City of Franklin

Meeting Agenda

3. Consideration Of Resolution 2025-51, A Resolution Approving A Development Plan For Harpeth Village PUD Subdivision, With 4 Modifications Of Development Standards (Signage, Building Elements), For The Property Located East Of Franklin Road And North Of Harpeth Industrial Court, Located At 318 Franklin Road, 1117,1121, And 1123 Harpeth Industrial Court. Establishing a Public Hearing On October 13, 2026
   FMPC 8/27/26, 6-0-1 (recused) (MOS 1: 6-0; MOS 2: 6-0; MOS 3: 6-0; MOS 4: 6-0)

Consideration Of Resolution 2025-51, A Resolution Approving A Development Plan For Harpeth Village PUD Subdivision, With 4 Modifications Of Development Standards (Signage, Building Elements), For The Property Located East Of Franklin Road And North Of Harpeth Industrial Court, Located At 318 Franklin Road, 1117,1121, And 1123 Harpeth Industrial Court. Establishing a Public Hearing On October 13, 2026
FMPC 8/27/26, 6-0-1 (recused) (MOS 1: 6-0; MOS 2: 6-0; MOS 3: 6-0; MOS 4: 6-0)

127. Verify Autoturn Analysis

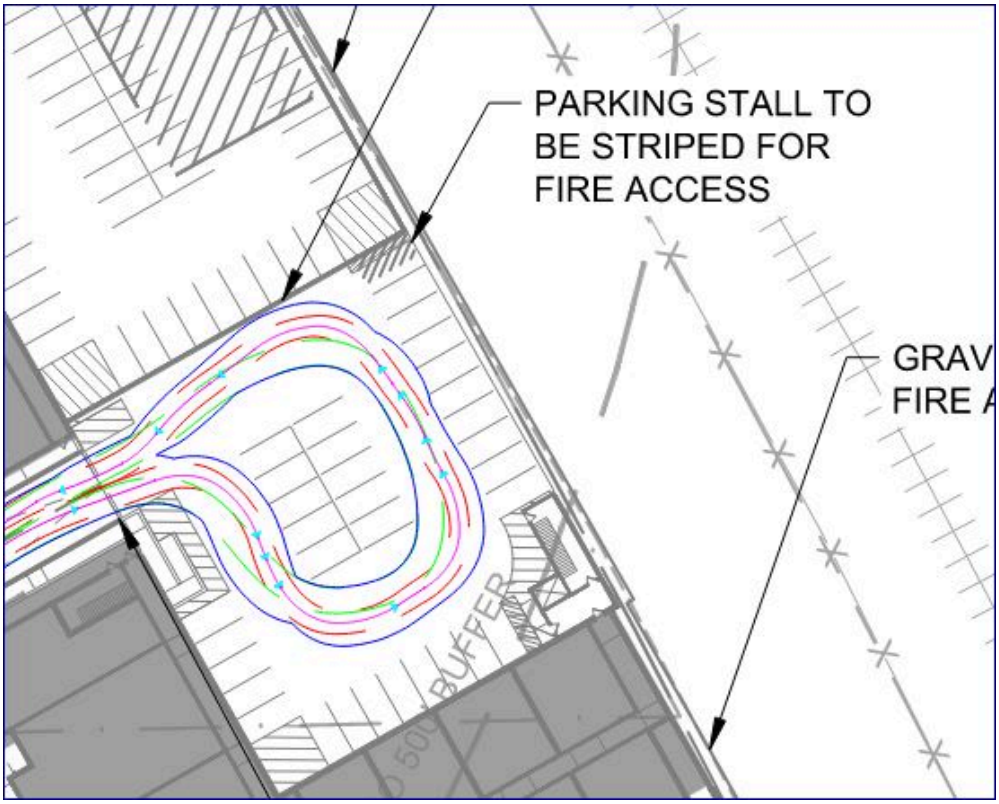
The previous comment, "The submitted autoturn analysis exhibits abrupt turning movements and wall to wall turning radii of less than those prescribed by the Fire Apparatus Turning Template. Staff is unable to reproduce the turning movement illustrated below while maintaining the required turning movement criteria" has not been addressed. Use of analysis software which does not uniformly apply the SD-7 Turning Template criteria for swept path analysis, including wall to wall turning radius, lock-to-lock time, minimum design speed, and disabling of "turn on spot" capability, is not acceptable.

Applicant shall correct Autoturn analysis and revise layout of the site as necessary to confirm full maneuverability for fire apparatus through the site.

27. Stormwater Requirements For Site Plan

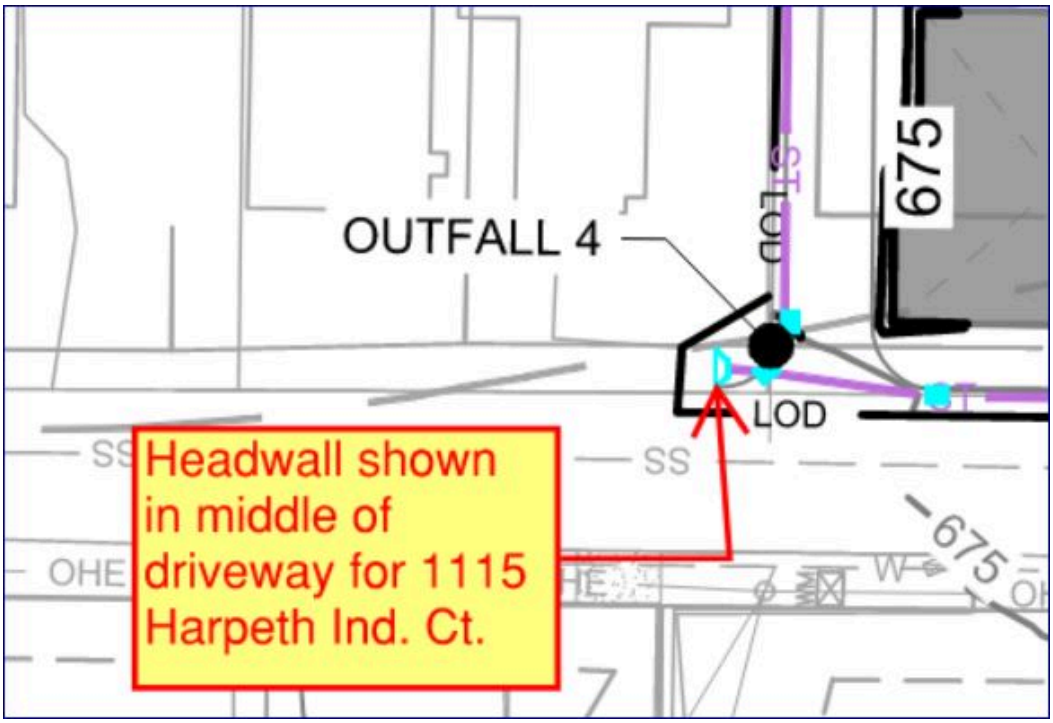
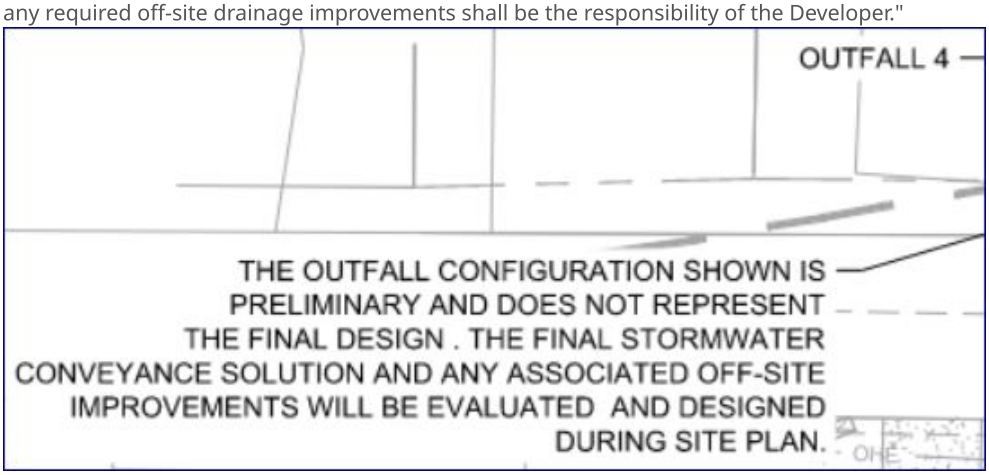
lance.fittro@franklintn.gov	At site plan, conceptual layout of storm infrastructure now shown on the Development Plan shall be evaluated for downstream conveyance capacity and necessary drainage easements. Outfall 4 does not work as currently depicted on the plans, and will not be accepted as a headwall daylighting to non-existent surface channel or draining back into the roadway. Failure to depict the neighboring property's driveway on the plans shall not permit installation of storm infrastructure or headwall in their driveway as currently shown on the proposed Development Plan.

While full design of off-site drainage improvements are not required with the Development Plan, off-site improvements for the proposed Outfall 4 shall be designed and constructed with the future Site Plan as necessary for off-site conveyance of stormwater flows from the site as determined by the City Engineer and in accordance with Stormwater Ordinance Sec. 23-106.(2)(i)(ii-v)

Applicant shall revise the note below on the Development Plan to add: "The construction and financing of

any required off-site drainage improvements shall be the responsibility of the Developer."
